# INDEPENDENT STRUCTURAL ANALYSIS FOR THE CORPUS CHRISTI NEW HARBOR BRIDGE PROJECT

### TOWER FOUNDATION CAP

DOCUMENT NUMBER: TM1002

08/12/2022

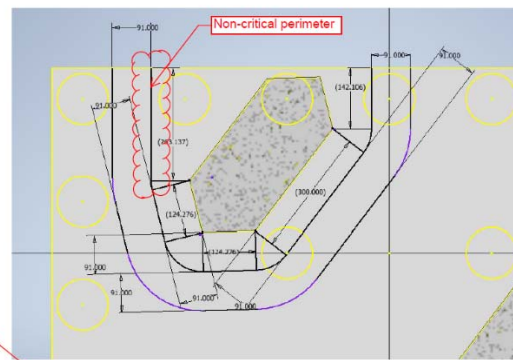
1. Two-Way Shear, Pgs 27 to 30: The calculations provided by the DLE contain two significant issues in the application of AASHTO LRFD § 5.13.3.6.1 for Two-Way Shear.

- a. The critical perimeter  $b_o$  is specifically defined at a minimum distance of  $0.5d_v$  from the perimeter of the reaction area. The perimeter selected by the DLE is not the critical failure plane, and the perimeter defined by the ISA is governing.

- b. The contribution of the drilled shafts shown in the DLE calculation is incorrect per AASHTO. Per AASHTO LRFD § 5.13.3.6.1, “Where a portion of a pile lies inside the critical section, the pile load shall be considered to be uniformly distributed across the width or diameter of the pile, and the portion of the load outside the critical section shall be included in the calculation of shear on the critical section.” The contribution from the drilled computed by the DLE shown in the figure below is significantly overestimated.

Any inclusion of the drilled shaft within  $d_v$  is unconservative, and the shaft contribution shall only include that portion within  $d_v/2$  per AASHTO LRFD § 5.13.3.6.1. The DLE shows approximately 2.5 shafts within this unconservative perimeter giving a pile resistance of  $2.5 \times 15,400 \text{ kips} = 38,500 \text{ kips}$ , versus the 55,046 kips presented in the table above. This results in a shear capacity of  $\phi V_n = 63,315 + 38,500 - 2,943 = 98,872 \text{ kips}$ . From DLE's foundations loads,  $V_u = 111,900 \text{ kips}$ , and therefore the **D/C is 1.13** does not meet AASHTO LRFD.

As shown in Appendix B3, and following the AASHTO LRFD 5.13.3.6.1 requirements, a more critical perimeter must be considered, that encircles the perimeter of the pier footprint by  $d_v/2$ . Following this approach as defined in Appendix B3 and using the DLE's loads, the **D/C is 1.21**, which is significantly over capacity.

Figure 6: Transverse Bending Demand under Governing Strength III Load Combination ( $\eta_1 = 1.05$ )

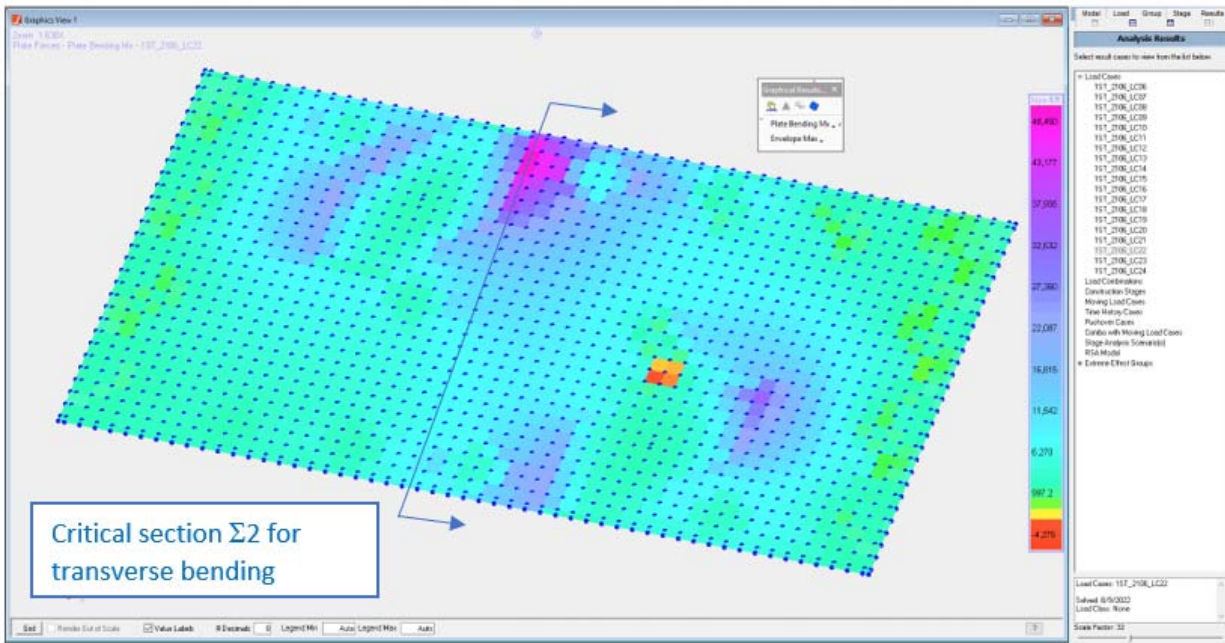
As shown in the Figure 6, the bending demand is concentrated on the side of the section closest to the pier leg carrying the maximum axial load. An attempt to address this concentration of the bending demand has been considered in the design, as evidenced by the local increase of bending reinforcement provided in this area: refer to Figure 1, where 3 layers of 41 #9 bars [bar marks F0901 on drawing NHB 55] are provided at this  $\frac{1}{2}$  section. Although the axial + bending demand capacity ratio over the full section is adequate, the ISA team estimates that given the dimension of the foundation cap and the localized nature of the demand, the local reinforcement must be sized to adequately resist the localized demand over a  $\frac{1}{2}$  section. With the reinforcement provided, the bending demand exceeds the capacity with a demand-to-capacity ratio, D/C = 1.25, as shown in the interaction plot in Figure 7. Also, bars F0901 should be extended by an additional 5' past section  $\Sigma 2$  to be fully developed, per AASHTO LRFD §5.11.2 and §5.8.3.5. (see Figure 8).

Figure 9: Detail of Critical Perimeter  $b_o$  for 2-Way Action: Dimension, Distance to Tower Leg, Intersection with Drilled Shafts.

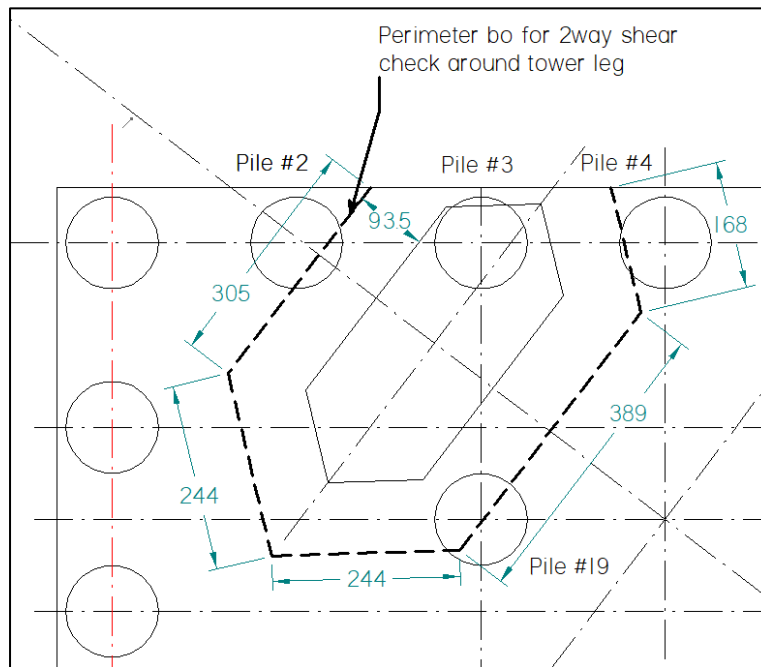
The two-way action checks around the pier leg have been carried out by the ISA team following the recommendation of AASHTO LRFD §5.13.3.6.1. The critical perimeter  $b_o$  is defined in Appendix A1 above. As illustrated in Figure 9 below, portions of drilled shafts 2, 3, 4, and 19 fall inside the perimeter  $b_o$ . Per AASHTO LRFD §5.13.3.6.1, “Where a portion of a pile lies inside the critical section, the pile load shall be considered to be uniformly distributed across the width or diameter of the pile, and the portion of the load outside the critical section shall be included in the calculation of shear on the critical section.”

$V_u = 81,617$  kips  $> V_r = 70,596$  kips →  $D/C = V_u / V_r = 1.16$

Using the demand on the tower leg evaluated by the ISA at the Strength limit state, the two-way shear demand around the tower leg exceeds the two-way shear capacity of the foundation cap with  $D/C = 1.16$ .

Figure 10: Shear Stress Distribution Along Plane AB for ISA Governing STR III Load Combination

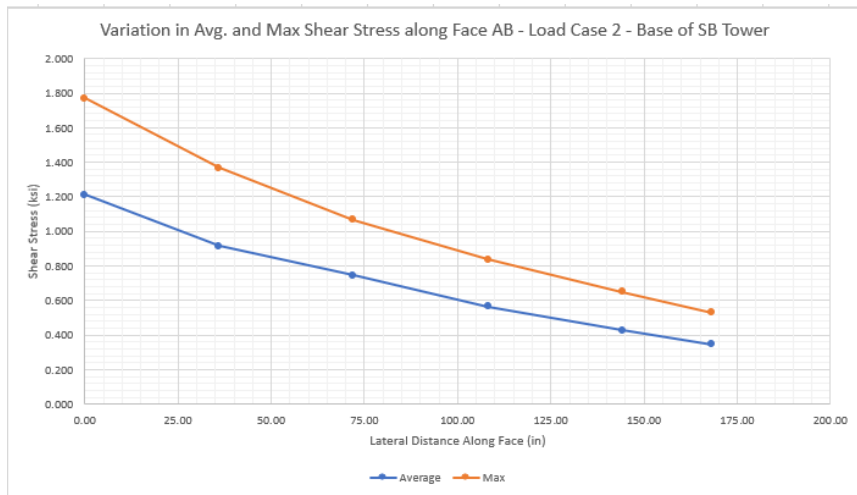
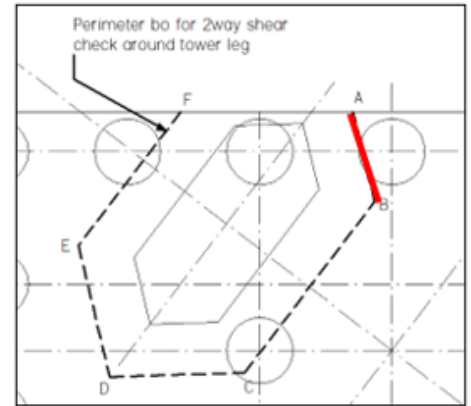
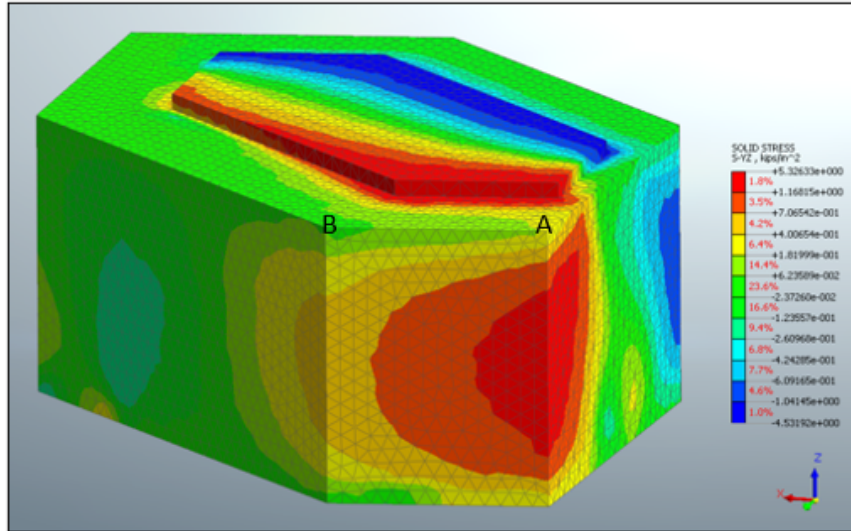
The average shear stress demand under Strength III in the area AB shown in Figure 10 varies between  $v_u = 1.2$  ksi at node A and  $v_u = 0.4$  ksi at node B, which can be compared to the shear stress capacity evaluated in Appendix B3 above for the perimeter  $b_o$ :  $vr = V_r / (b_o \cdot d_v) = 70,596 \text{ kip} / (1,350 \text{ in} * 187 \text{ in}) = 0.28 \text{ ksi}$ .

Over the face AB, the shear stress exceeds the capacity with D/C ranging between 4.3 and 1.4.

The maximum factored shear (averaged through the depth of the section) from the brick-element finite element model shown in Figure 10 is 1.2 ksi. This agrees with results from plate element models described herein and with the models discussed in the ISA Phase 1 Report and the ISA Phase 2 Part 1 Report. Regardless of the amount of reinforcement provided, both AASHTO LRFD and ACI-318 limit the maximum factored allowable shear. AASHTO LRFD and ACI limits shear to  $\phi 0.192 \sqrt{f'_c}$ . With  $f'_c = 5.5$  ksi, this results in an allowable shear stress of 0.40 ksi compared to the demand of 1.2 ksi noted above.

Therefore, even if the maximum amount of shear reinforcement was provided (and it was not), the foundation cap section, as currently designed, cannot resist the design loading considered. The foundation cap needs to be thicker, or the tower legs need to be located further away from the edges, or the tower loads need to decrease, or some combination thereof.

Figure 12: Shear Stress Distribution Along Plane EF of Perimeter bo for ISA Governing STR III Load Combination

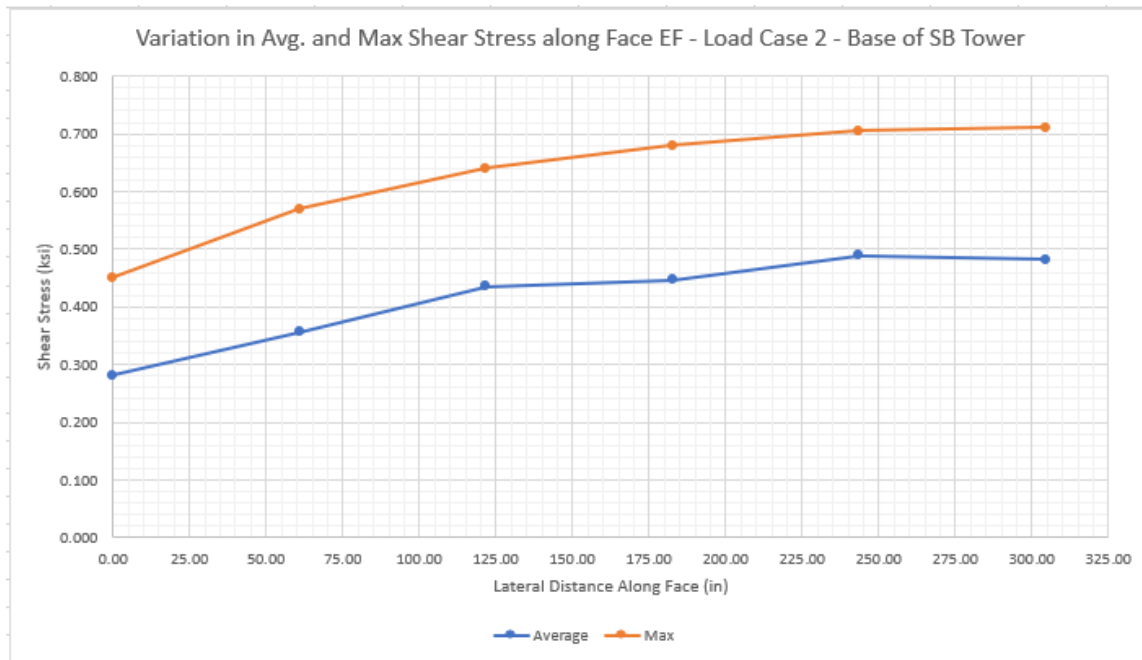
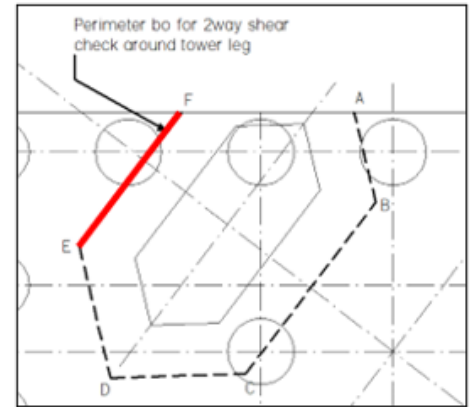
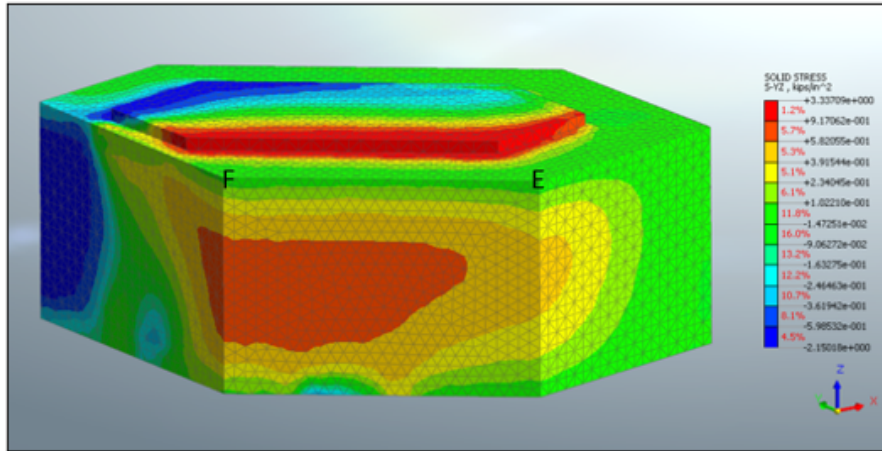
Similarly, the average factored shear stress demand under Strength III in the area EF shown in Figure 12 varies between  $v_u = 0.28$  ksi at node E and  $v_u = 0.48$  ksi at node F.

Over the face EF, the shear stress exceeds the capacity with D/C ranging between 1.0 and 1.7.

Figure 13: Shear Stress Distribution Along Plane AB of Perimeter  $b_o$  Evaluated by the ISA Team Based on DLE Foundation Loads

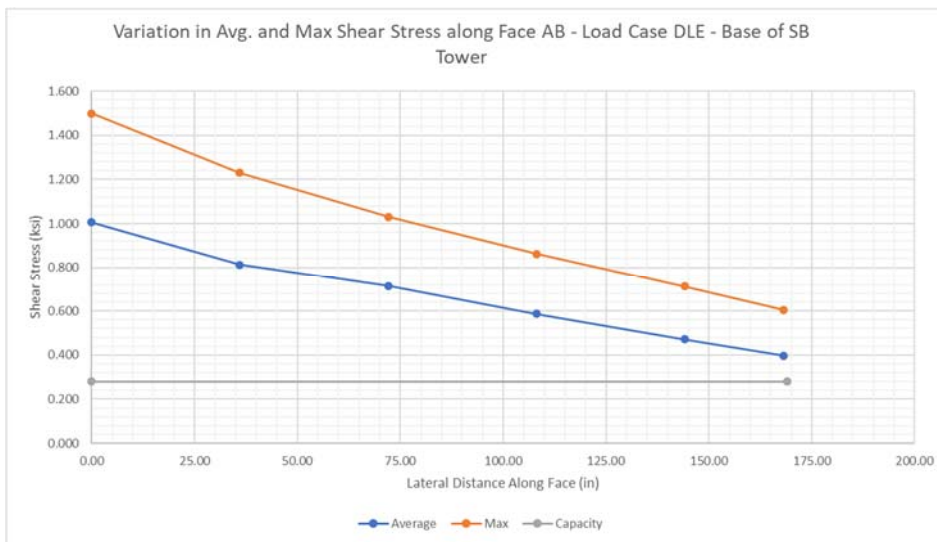
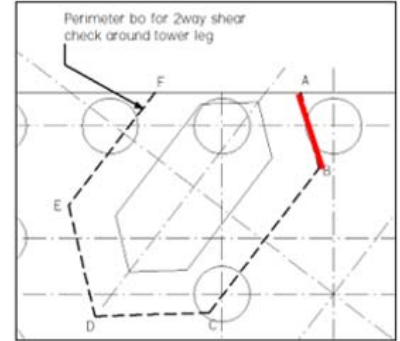
*Using the DLE foundation loads, the average shear stress over the face AB varies between 1.0 ksi and 0.4 ksi, which exceeds the capacity with D/C ranging between 3.5 and 1.4.*

Figure 14: Shear Stress Distribution Along Plane EF of Perimeter  $b_o$  Evaluated by the ISA Team Based on DLE Foundation Loads

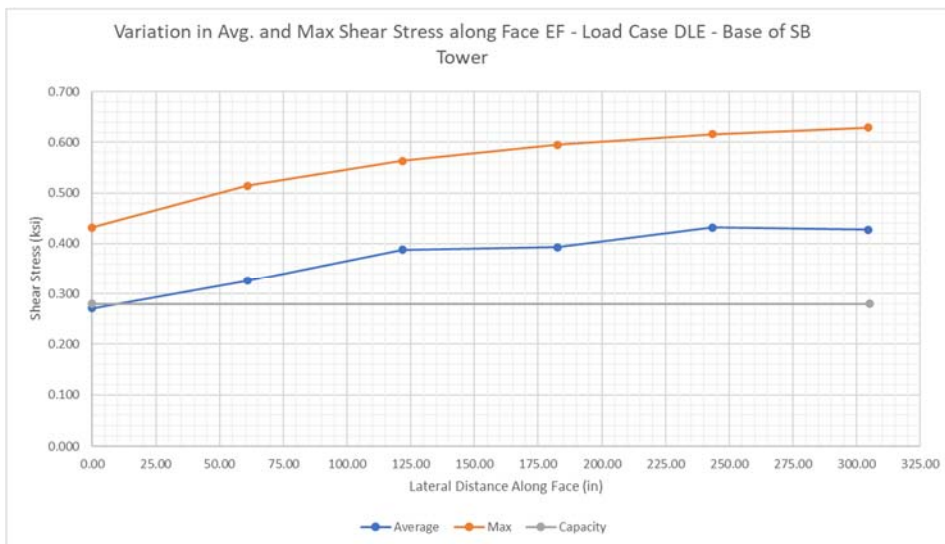
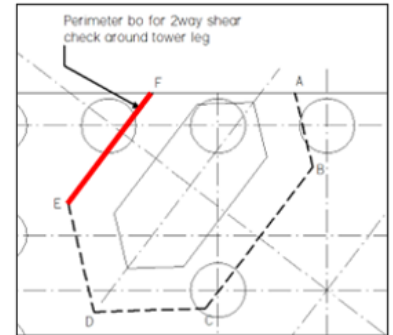
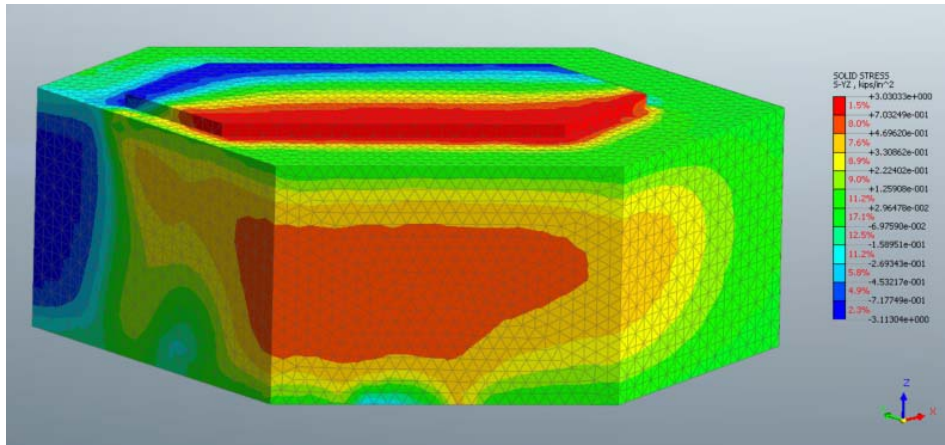
*Using the DLE foundation loads, the average shear stress over the face EF varies between 0.27 ksi and 0.43 ksi, which exceeds the capacity with an average D/C ratio of 1.33.*
